PROJECT TITLE: VANGUARD PRINTING ZONE ATLAS/DRNG. FILE #: J-14/D121

CITY OF ALBUQUERQUE
MUNICIPAL DEVELOPMENT DEPARTMENT
ENGINEERING DIVISION/DESIGN HYDROLOGY SECTION

Ref: Vanguard Printing File No. J14/D21

RE: REVISED DRAINAGE PLAN FOR VANGUARD PRINTING (J14-D21) REVISION
DATED 5/13/97

DWG 2425

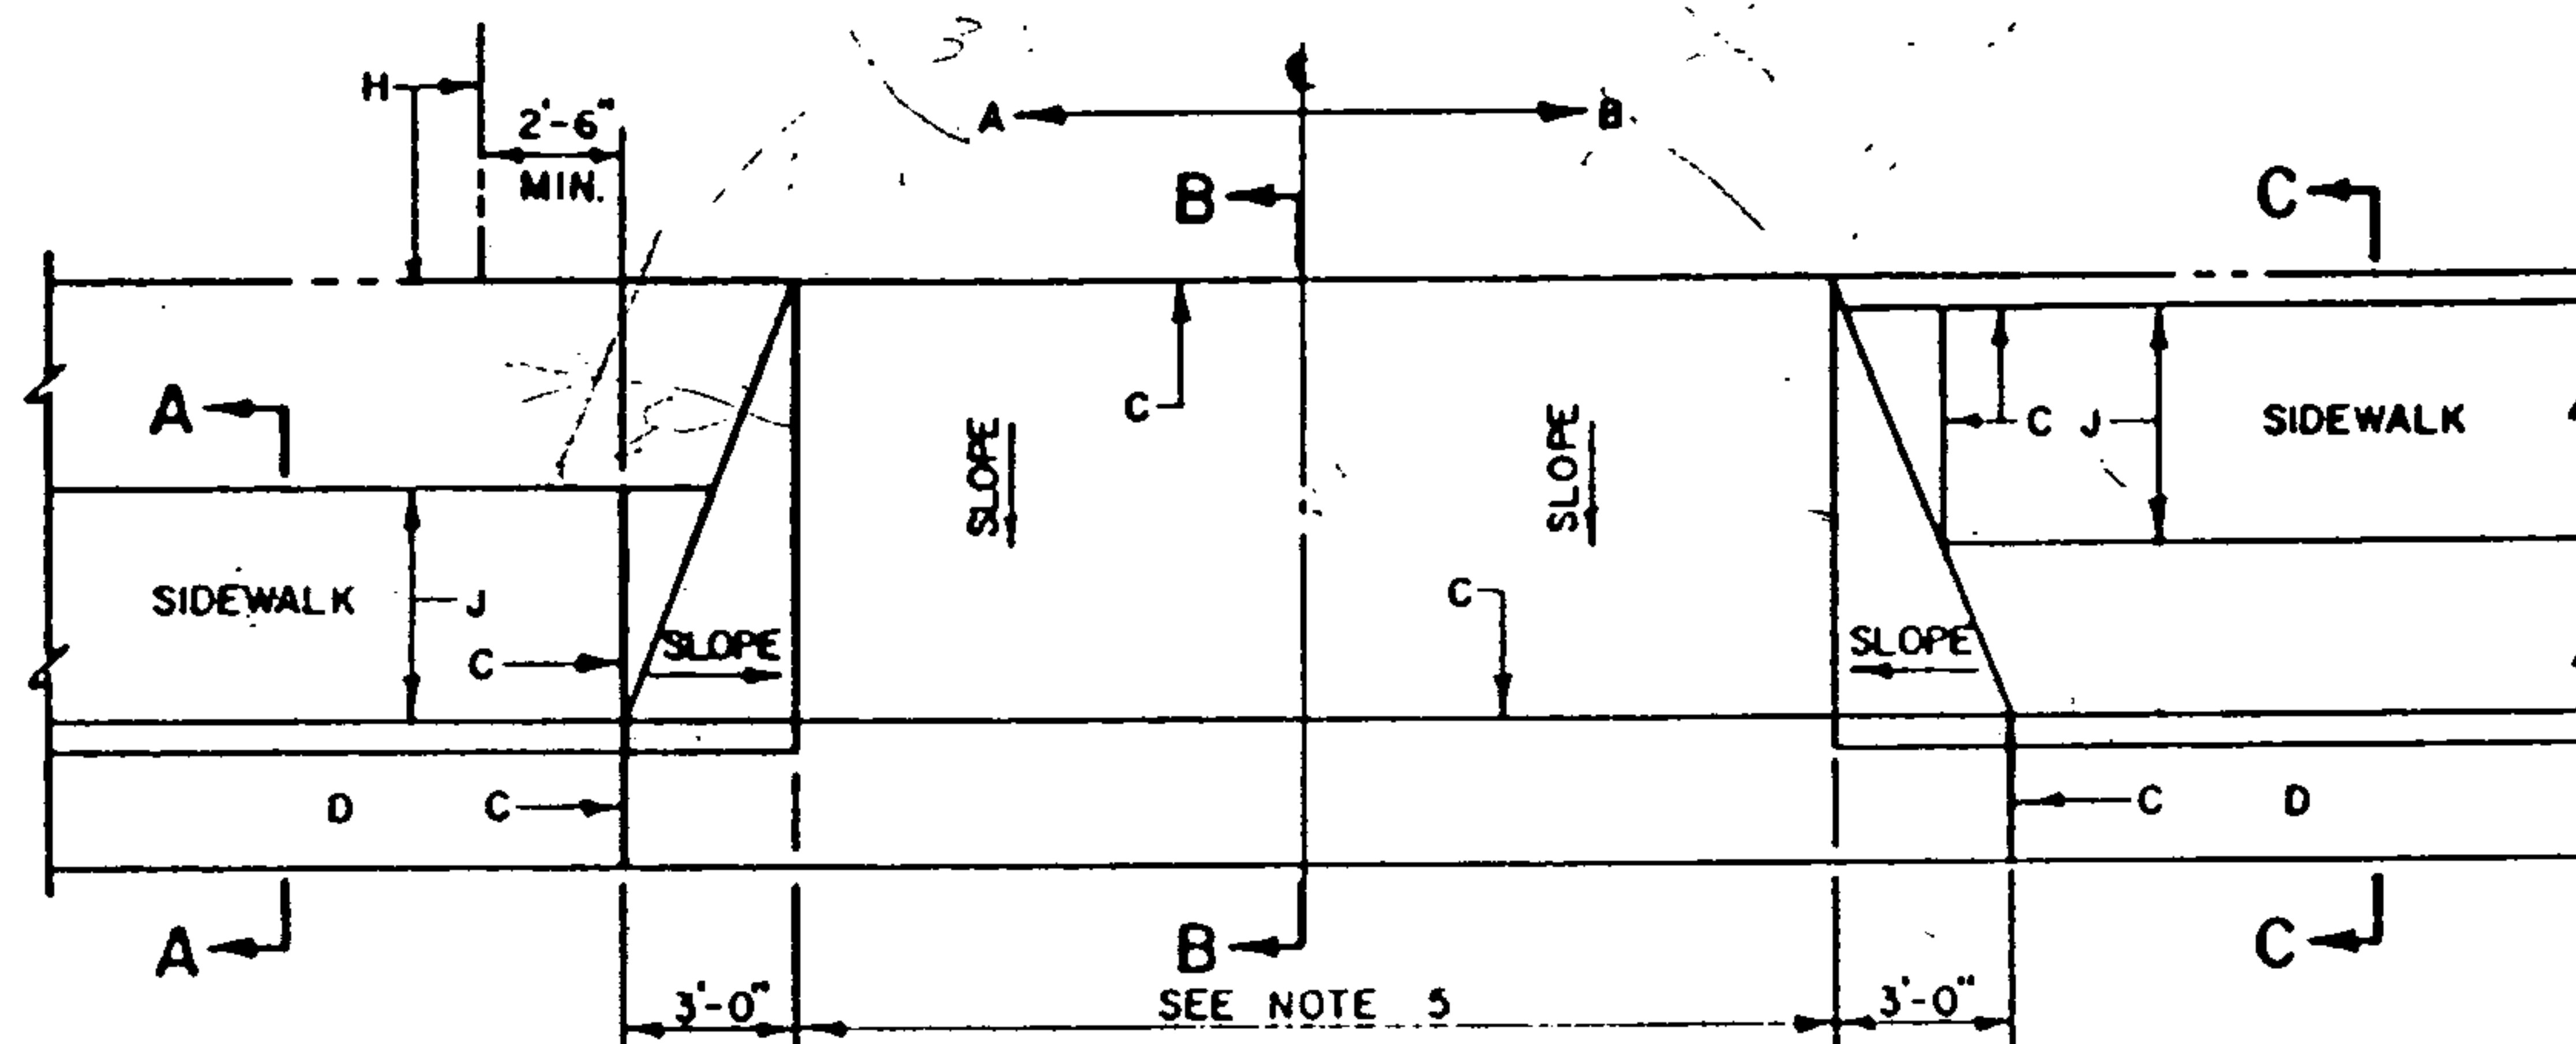
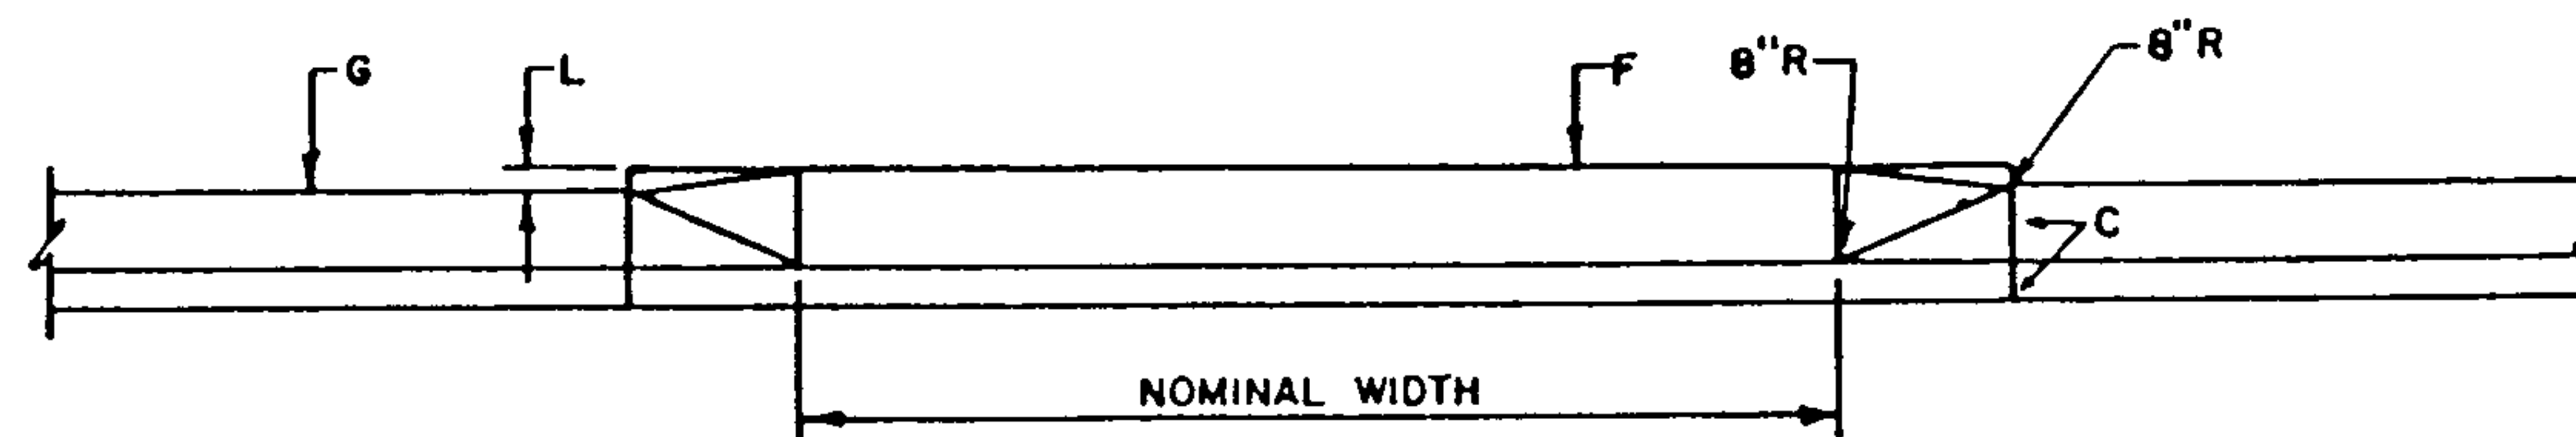
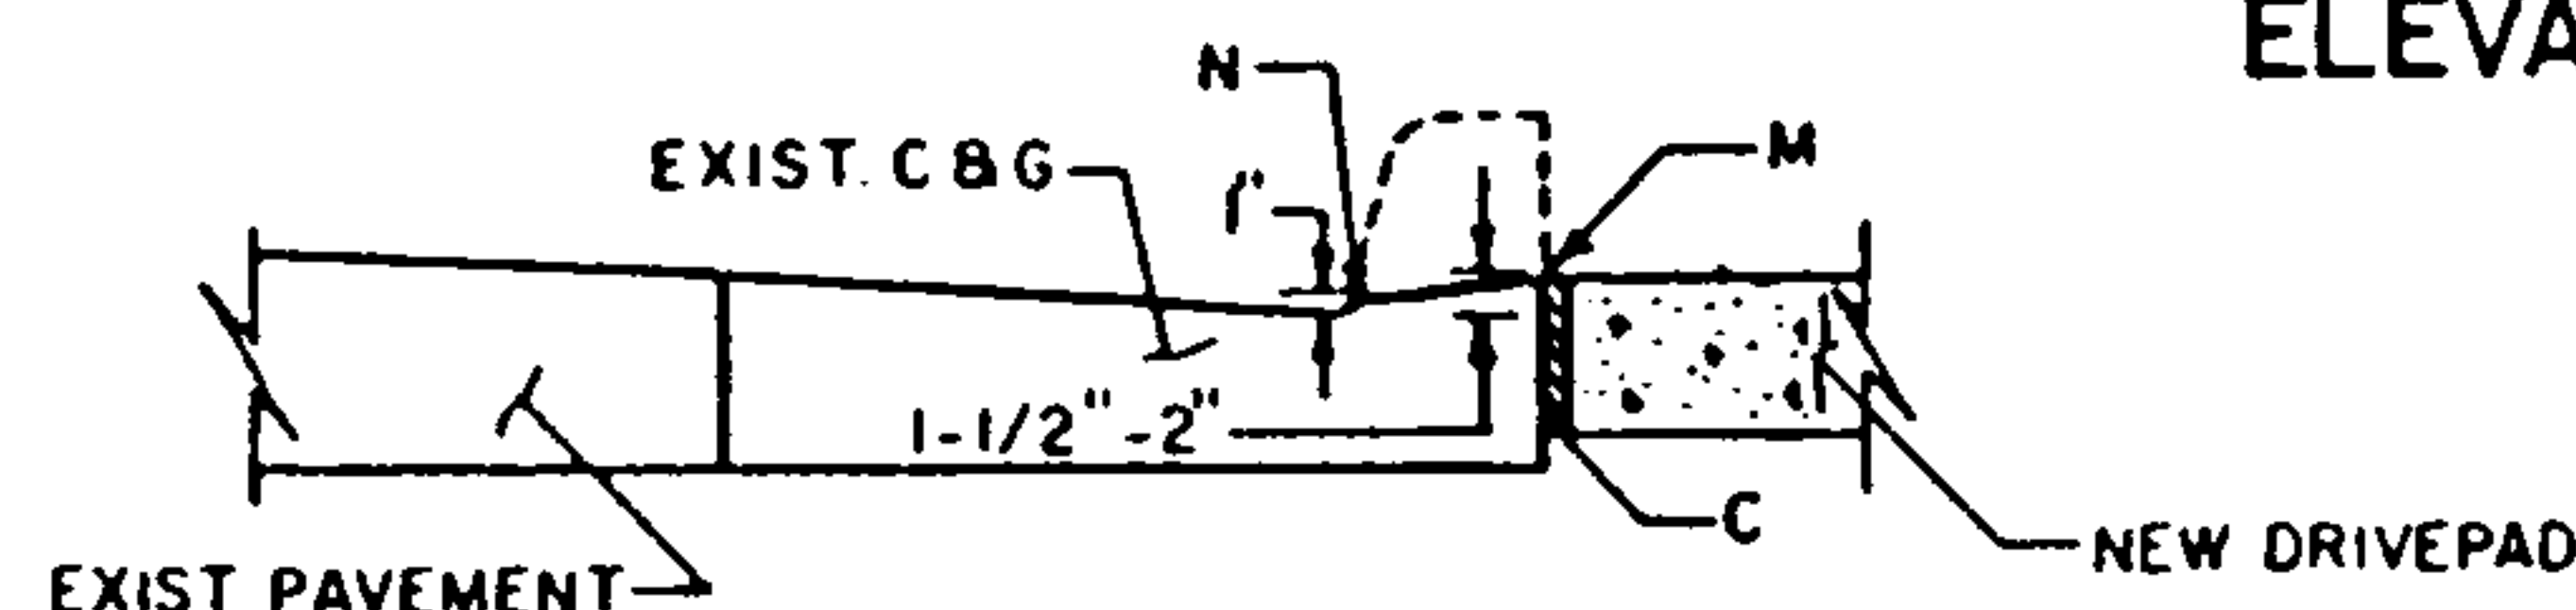
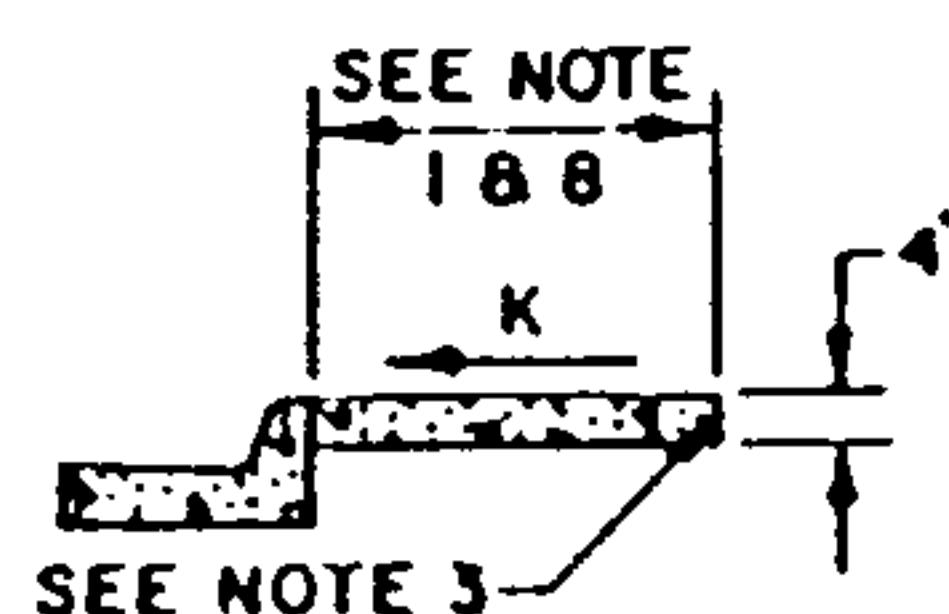
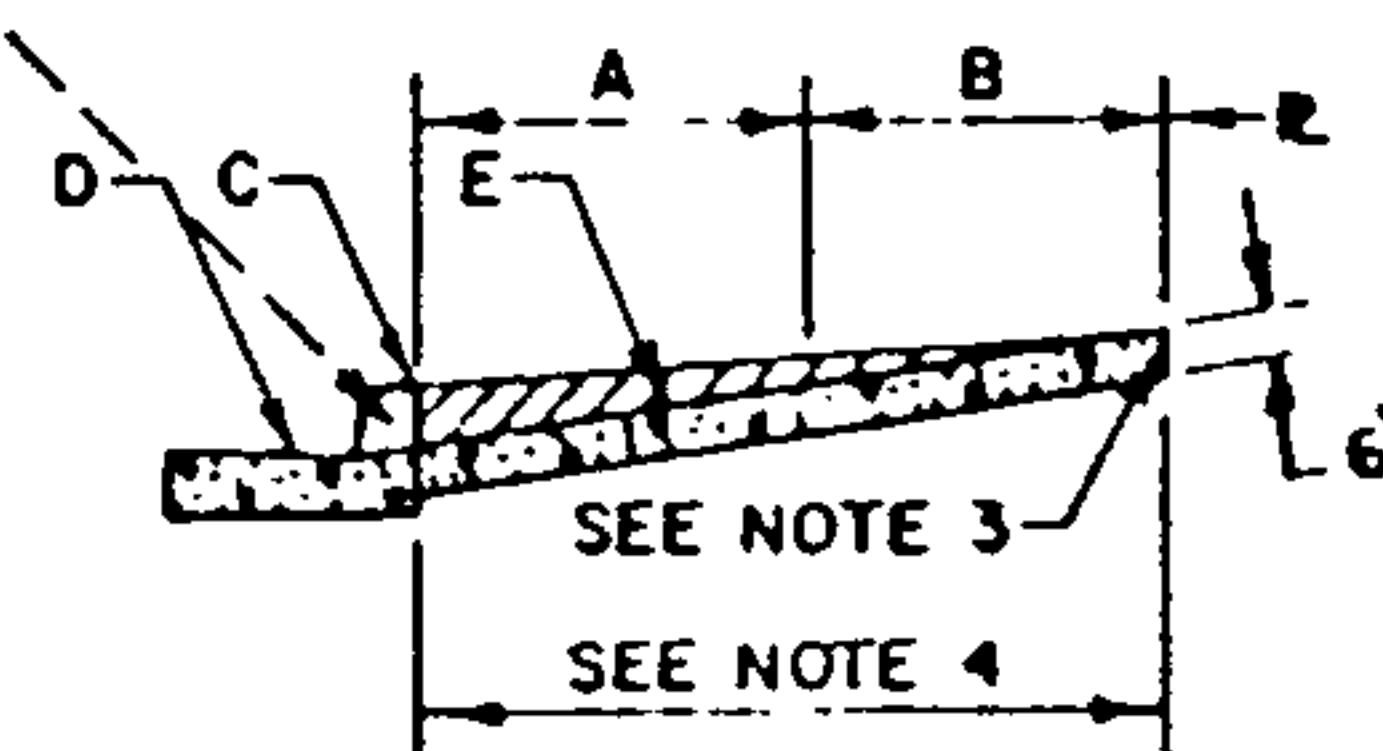
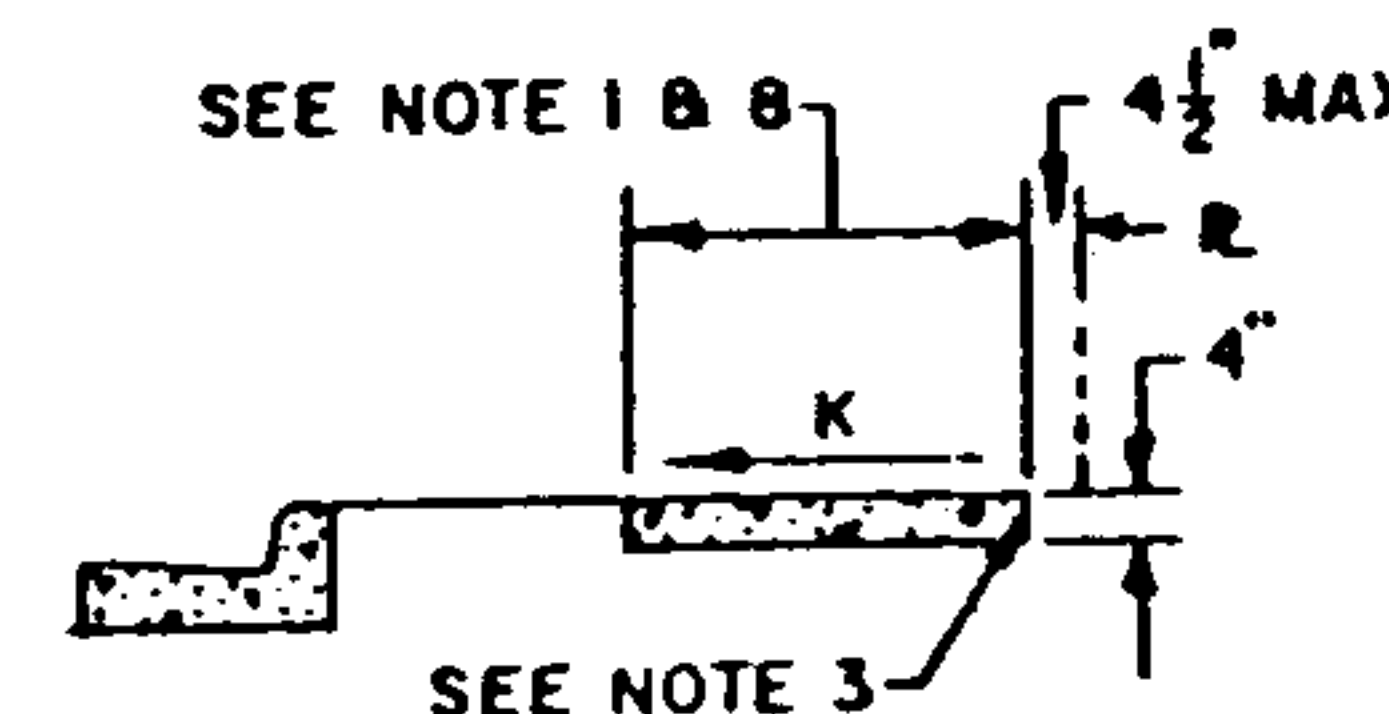
1. Will the increase flows to the alley be contained within the alley? Please address this question on the drainage plan.
2. Please provide the proposed and existing M.S.L. grades for the new curb and gutter and drivepads. Note: the finish grade at the property line must be 0.33' above top of curb per the City of Albuquerque Standard Specifications Drawings.
